STATE OF NEW HAMPSHIRE
PUBLIC UTILITIES COMMISSION

DOCKET DE 20-020

IN THE MATTER OF: Unitil Energy Systems, Inc.
2020 Least Cost Integrated Resource Plan.

DIRECT TESTIMONY

Diagram 1 – 37 Line / 4X1 Load Area

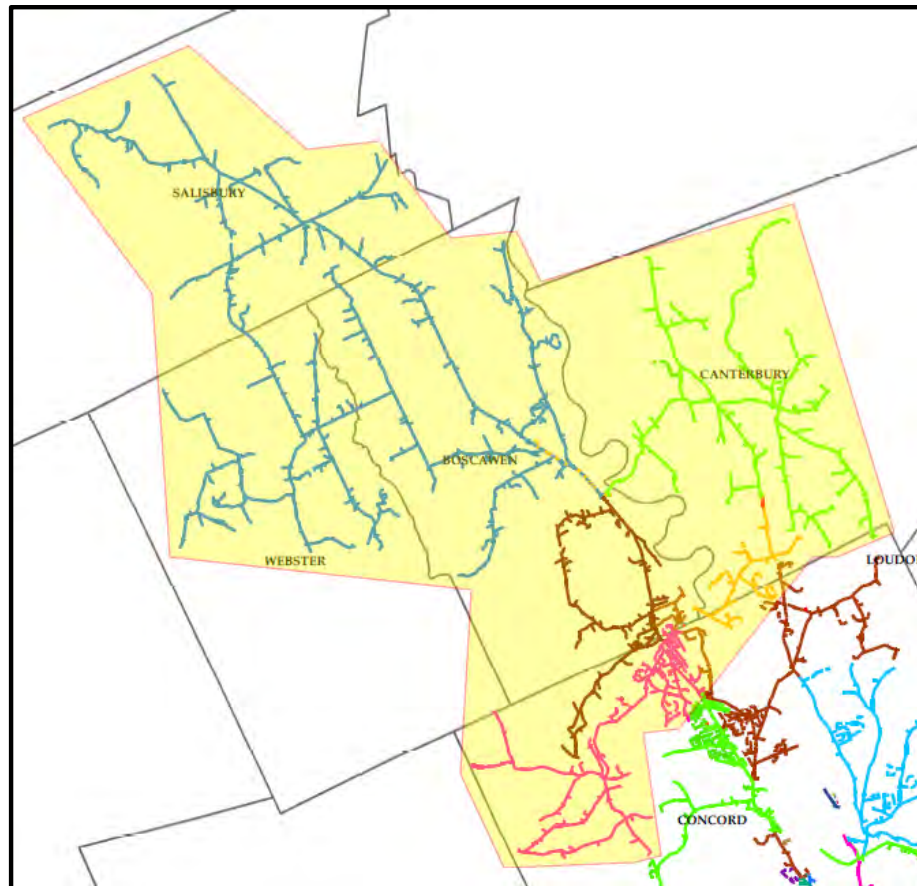
3 The 37 Line reconductoring was the grid need associated with the Company's non-
4 wire solution RFI discussed above. In Staff's review of the load data associated with the
5 constraint, it appears that the load of a single very large customer who participated in the
6 Company's ADR program (reducing its load by 700kW) has been reconstituted into the
7 projected load for the purposes of forecasting future loading constraints on the 37 Line.
8 Assuming the Company's ADR programs continue into the future, it is possible this would
9 inflate the loading on that circuit beyond what the actual future loading is likely to be during
10 times of the transmission system peak, which appear to coordinate roughly with the peaking
11 times on the 37 Line. It also appears possible that this single customer may have additional
12 load available to curtail. The Company never reached out to this customer to gauge whether

EXIT 17 LIQUOR STORE AND EV PARKING SPACE PLAN 4-21-20

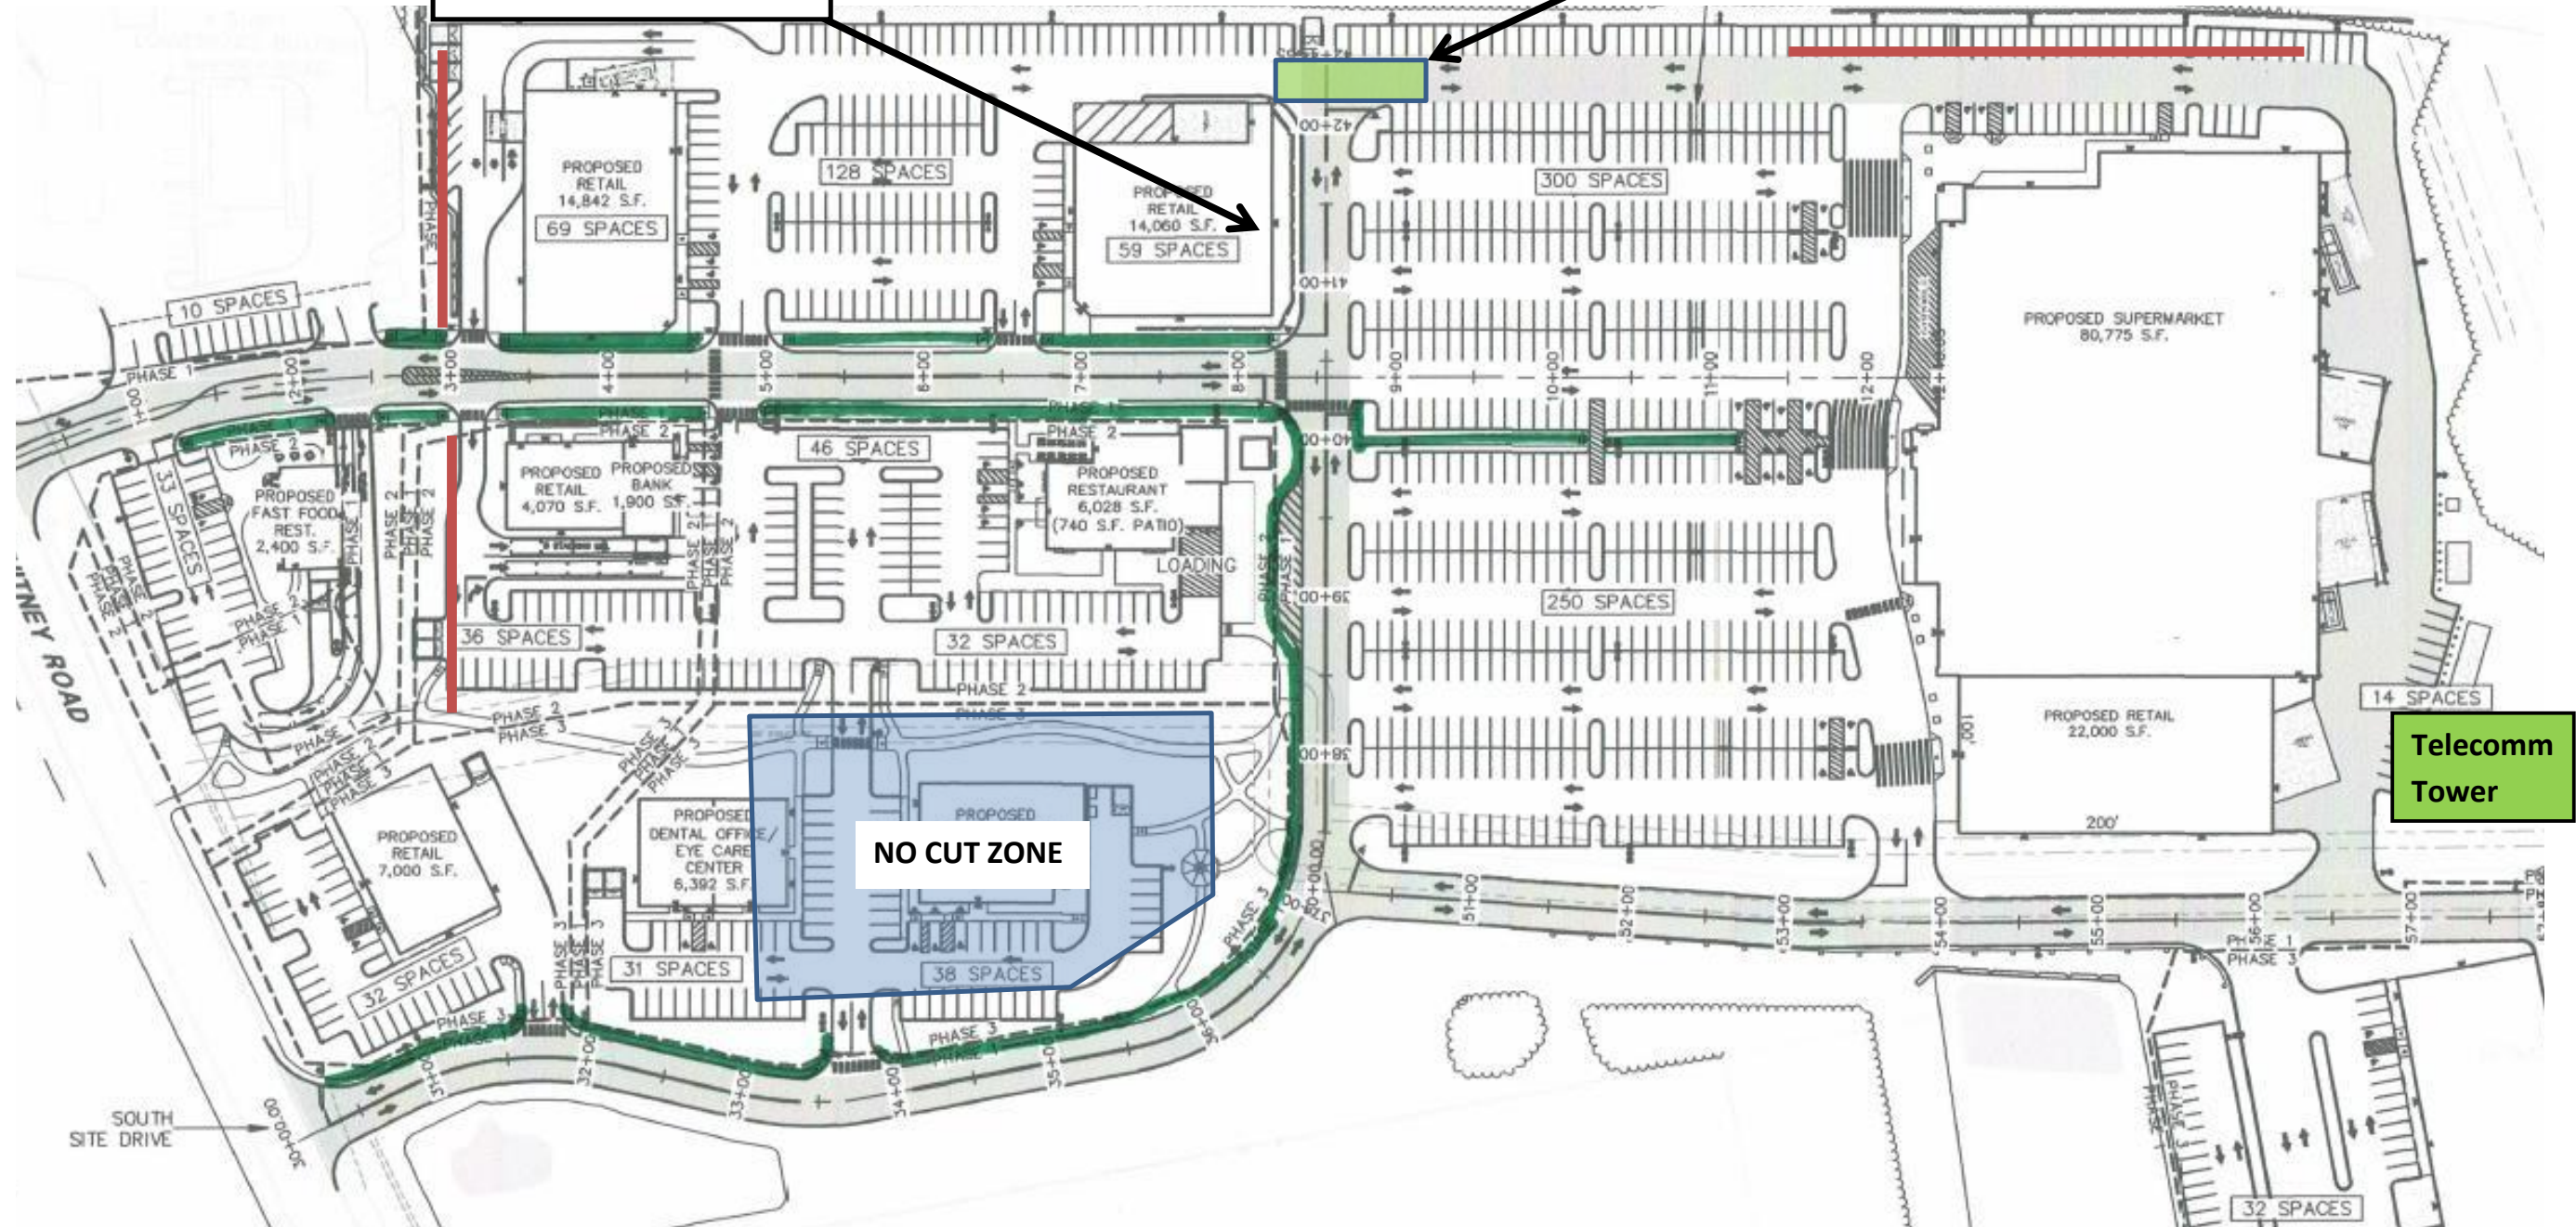
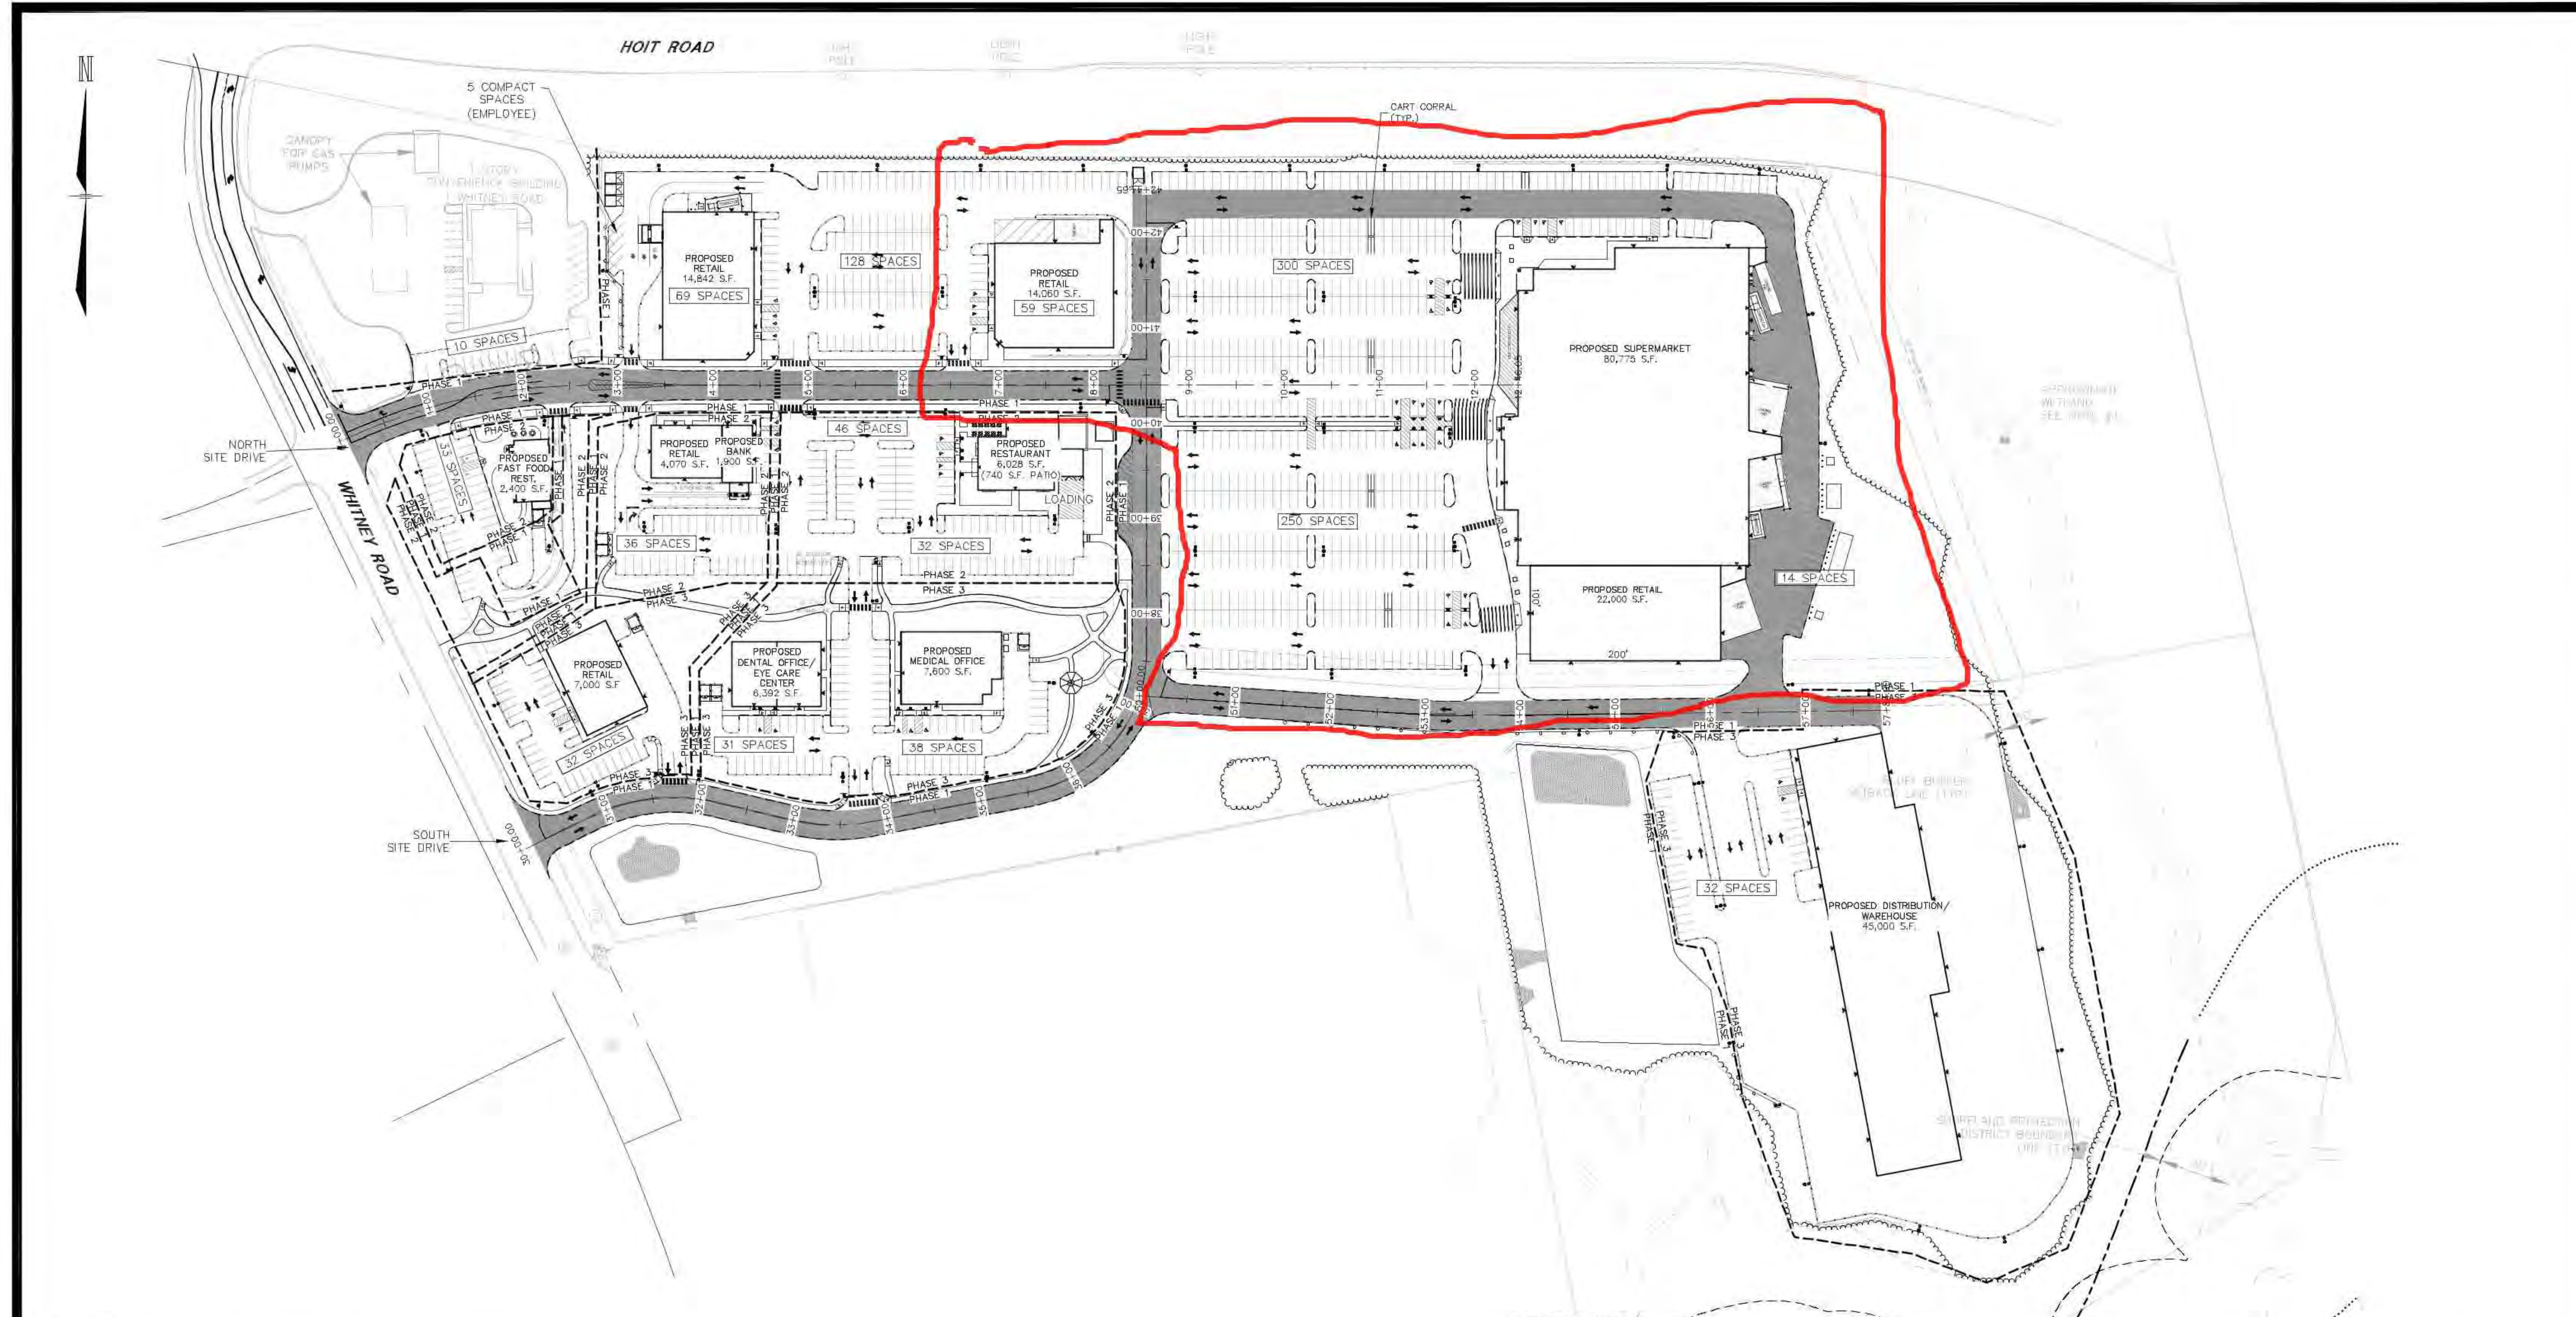
1 Hampshire Liquor Store. The Market Basket plans to install several electric vehicle charging
2 stations, including two Tesla superchargers, which would account for the vast majority of the
3 load at the development. More specifically, the Company is planning on up to two (2) 1MW
4 Tesla V3 Superchargers and two (2) to six (6) universal level 2 (150kW) chargers. The
5 Company has not yet assessed whether the Market Basket would need to provide a
6 contribution in aid of construction (CIAC) based on its usage and revenue projections, but in
7 order to avoid unreasonable cost shifting, it will be important that any CIAC calculation
8 developed by the Company utilizes a reasonable electric vehicle charging equipment realistic
9 utilization rate. Given that the superchargers will be located just a few exits North of several
10 charging stations which are also located on that same interstate, it is possible — even likely

- d. For system and distribution planning purposes Unitil will typically assume 75% of the EV charger ports being utilized at one time. In locations with both Level 2 and DC Fast Charge facilities the Company assumes 75% of the DC fast charge ports being utilized at the same time as 50% of the Level 2 ports. The assumption that 75% of the EV charger ports are being utilized at the same time is based on historical usage of a DC Fast Charge facility in Seabrook. However, in the case of sizing transformers for these facilities Unitil assumes all charging ports being utilized at the same time.
- e. The planned reconductoring will provide sufficient subtransmission line capacity to supply up to two (2) 1MW charge boxes and up to six (6) 150kW chargers.
